CITY OF ALBUQUERQUE

**RE: 2444 Louisiana Blvd NE
Conceptual Grading & Drainage Plans
Engineer's Stamp Date: No Date
Hydrology File: H19D093**

HYDROLOGY PLAN

C-100

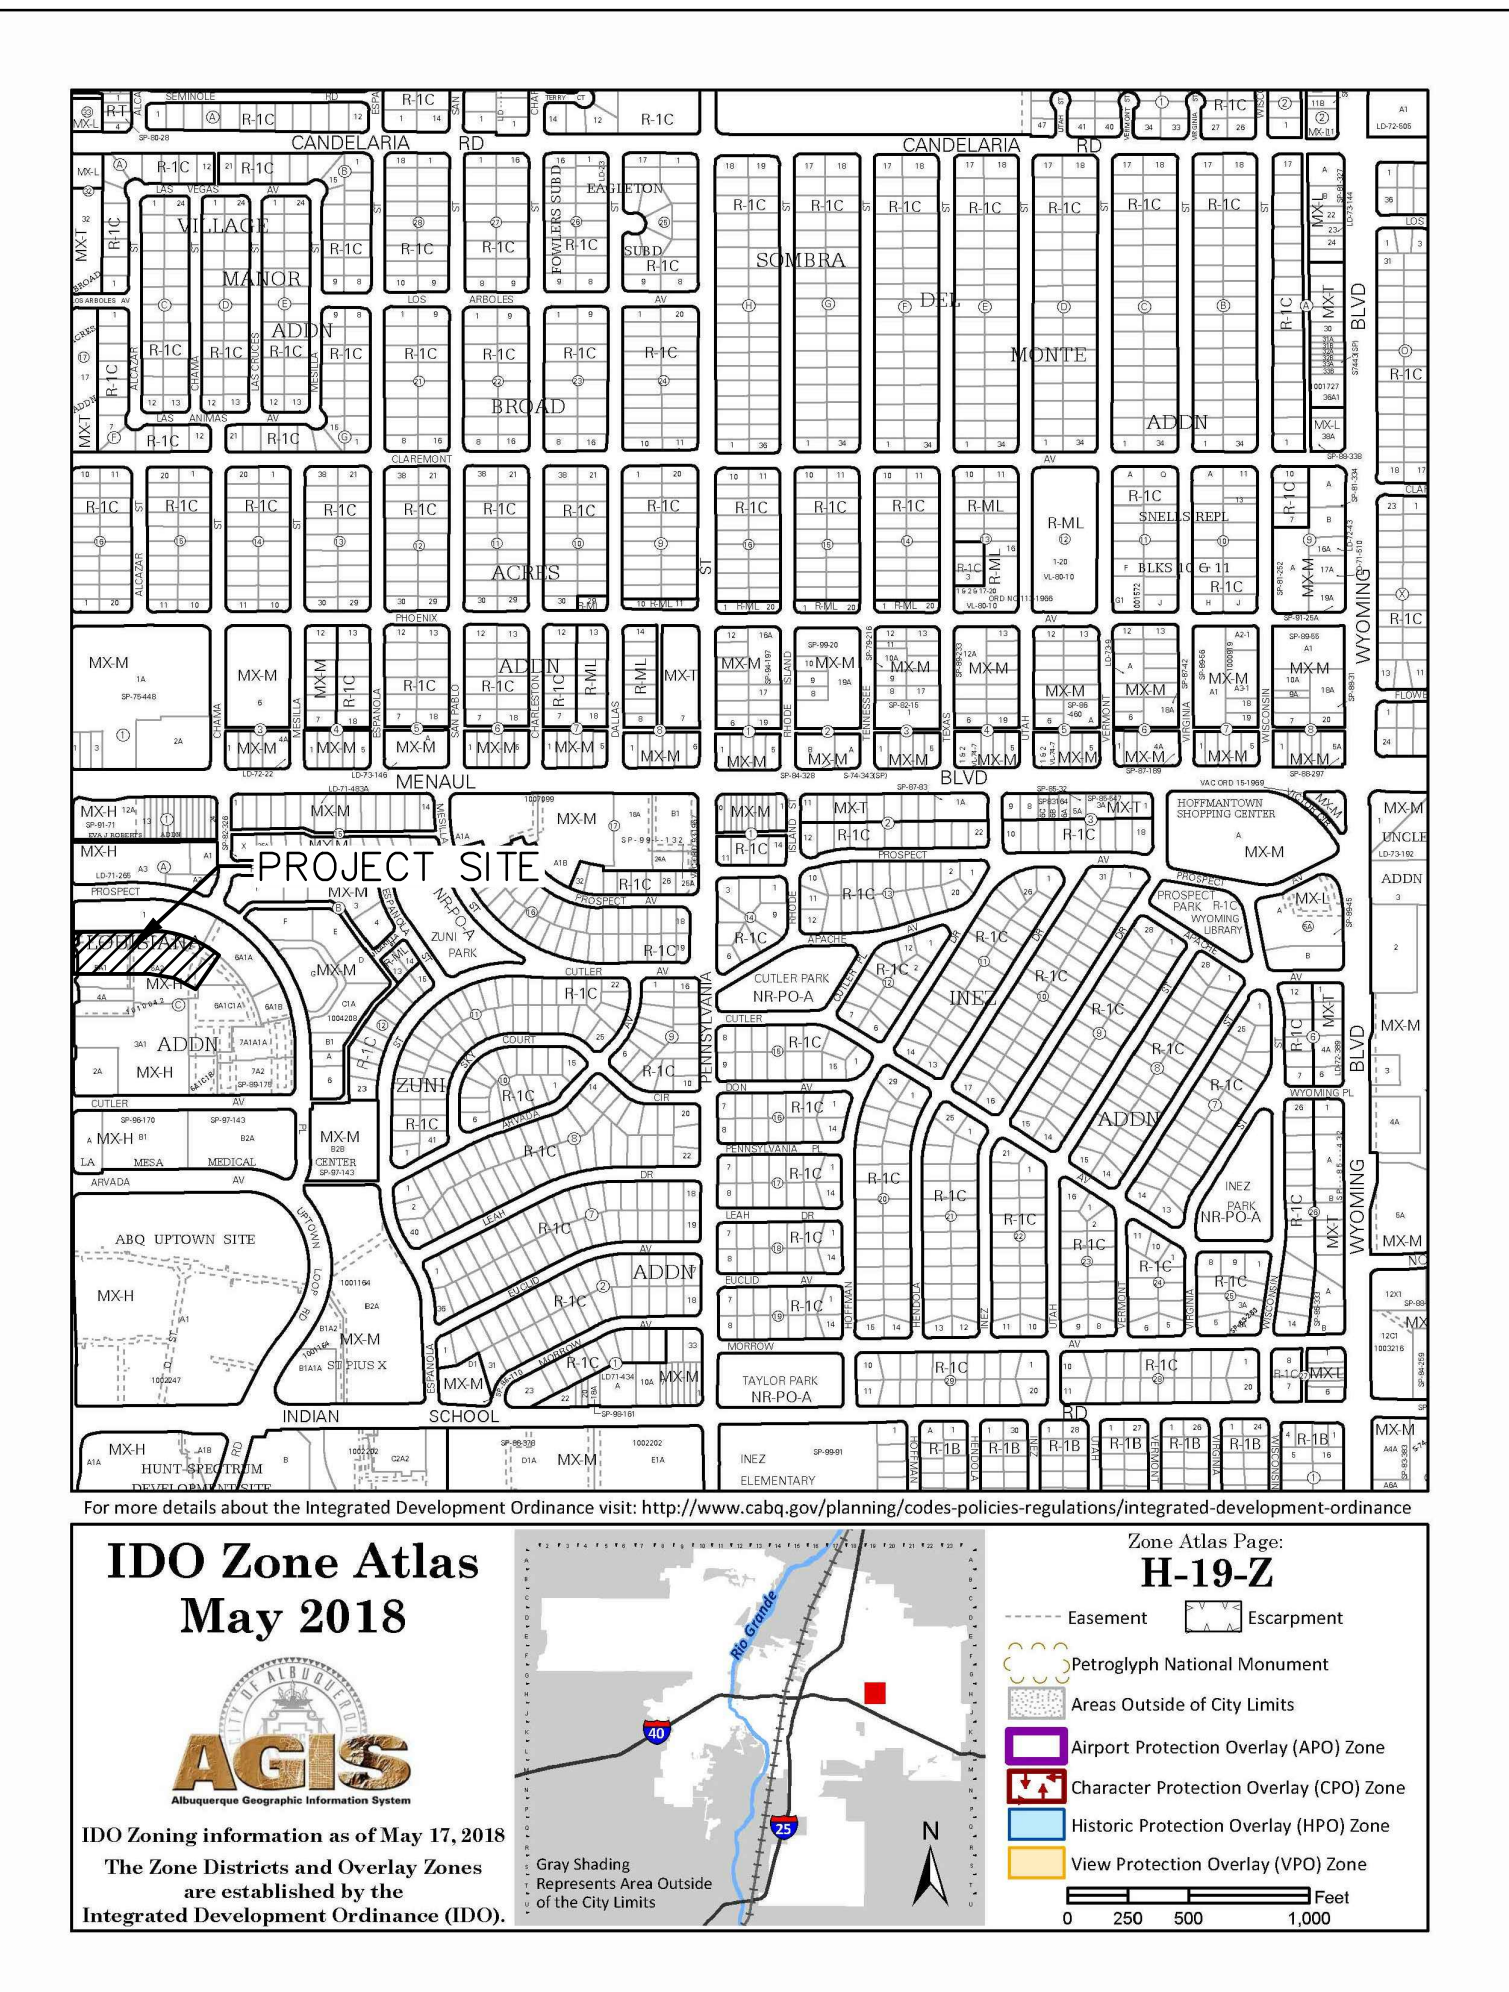
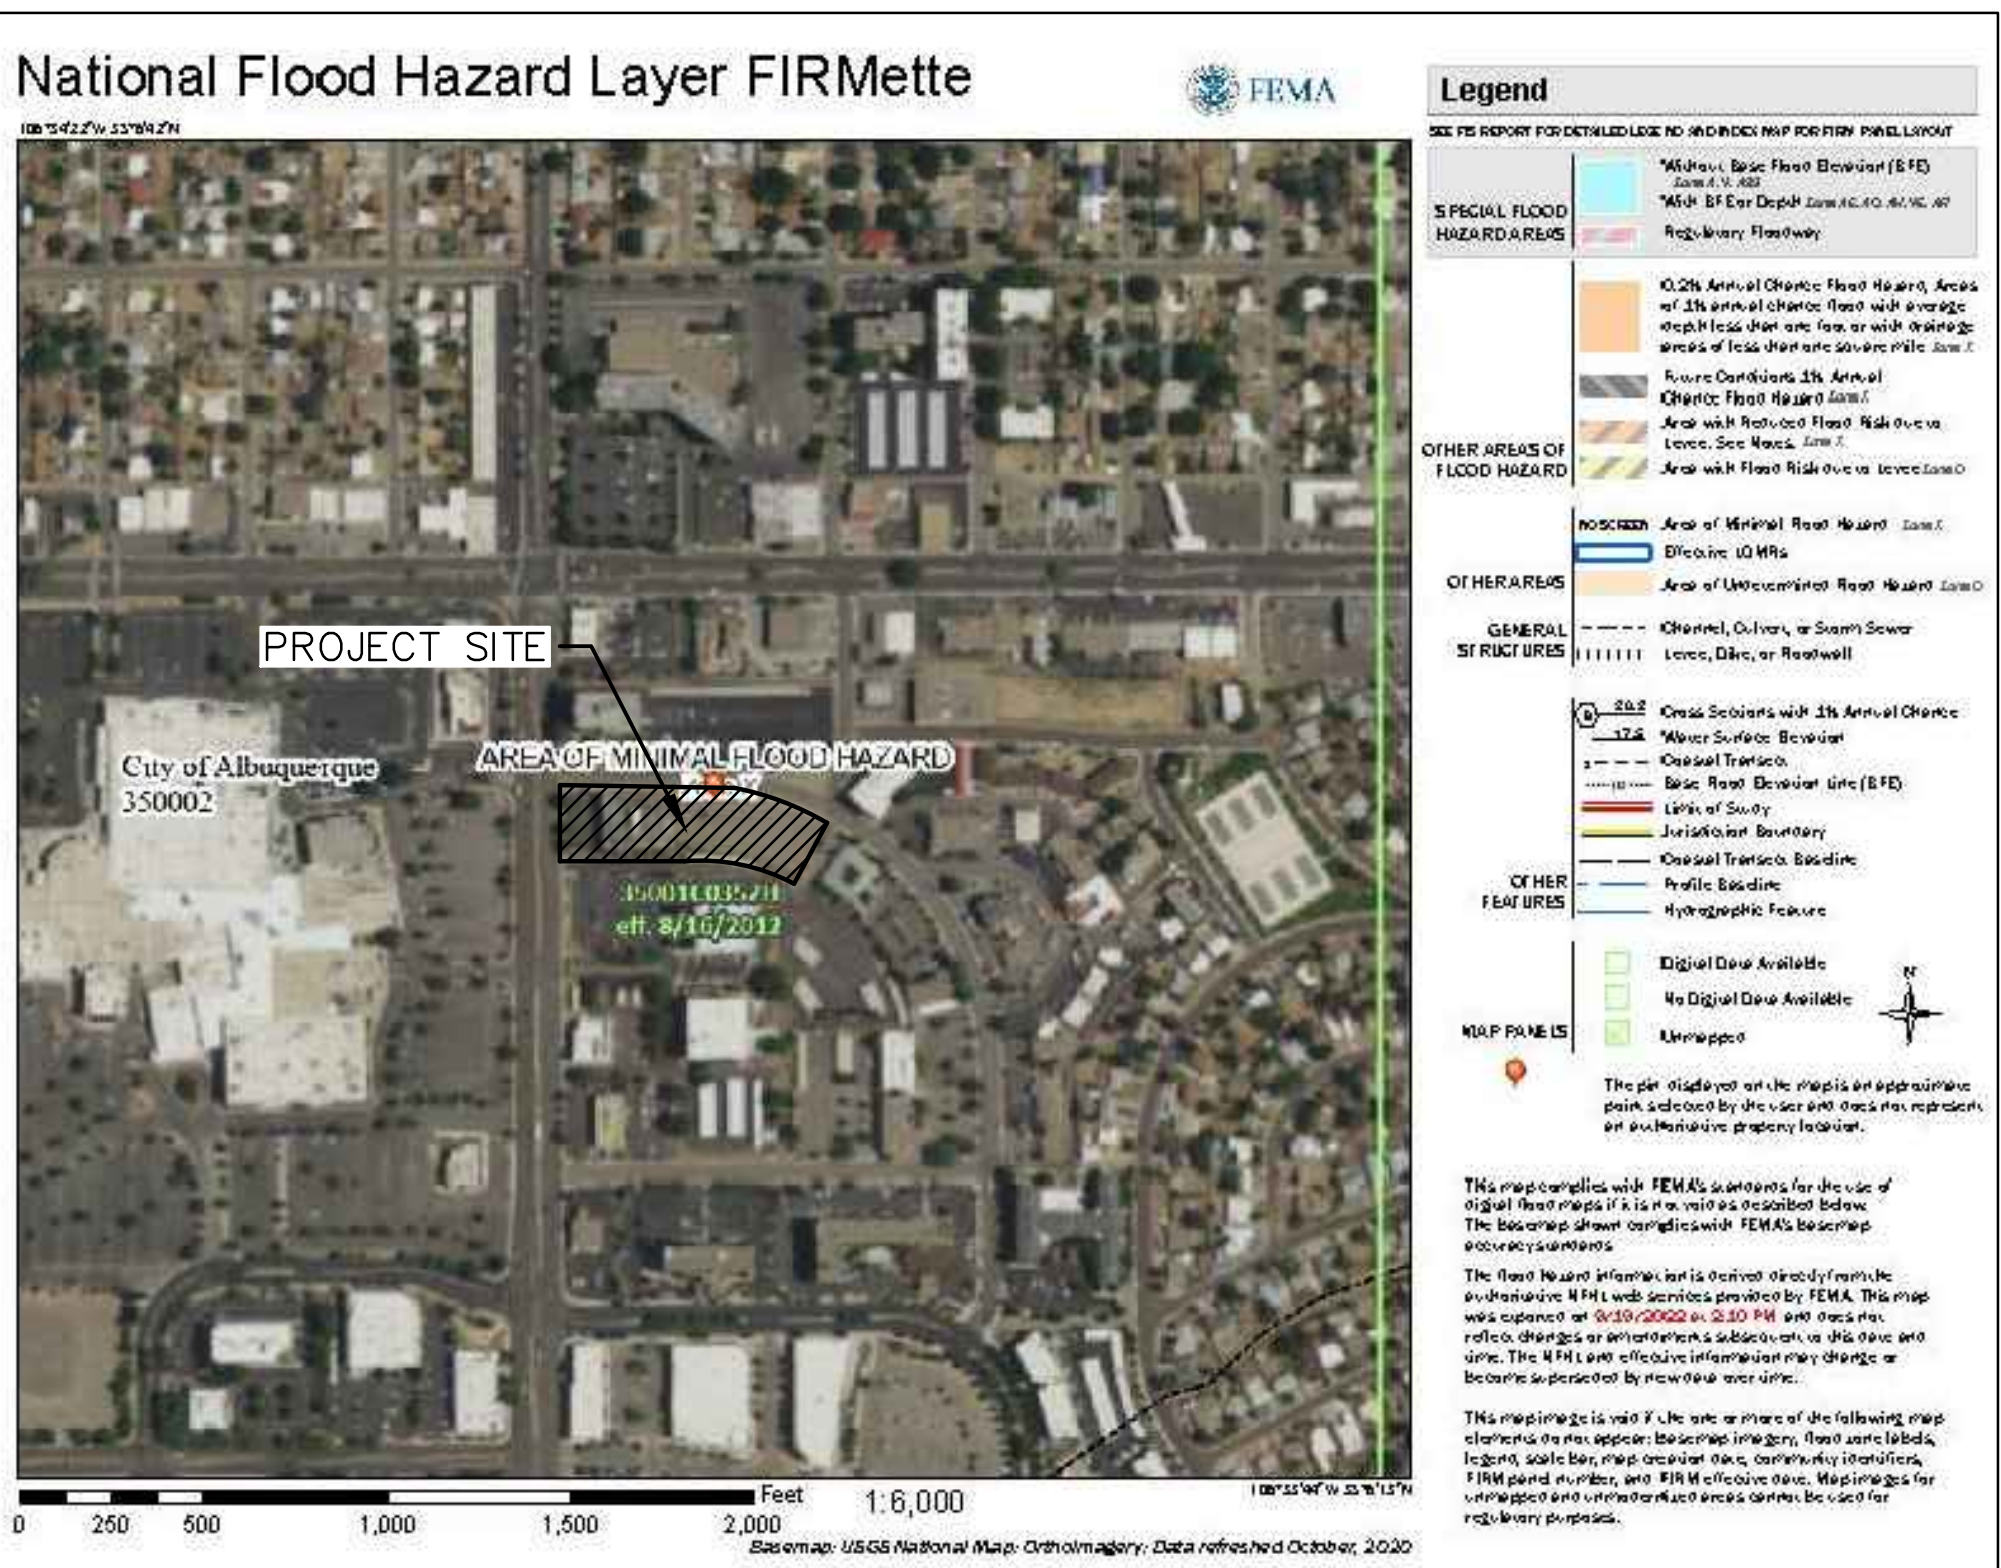
Based upon the information provided in your submittal received 09/01/2022, the Conceptual Grading & Drainage Plans are preliminary approved for action by the DRB for Site Plan for Building Permit.

1. Provide more detailed design as needed in order to obtain Hydrology's approval.
2. Please fill out the Waiver Application from Stormwater Quality Volume Management On-site.
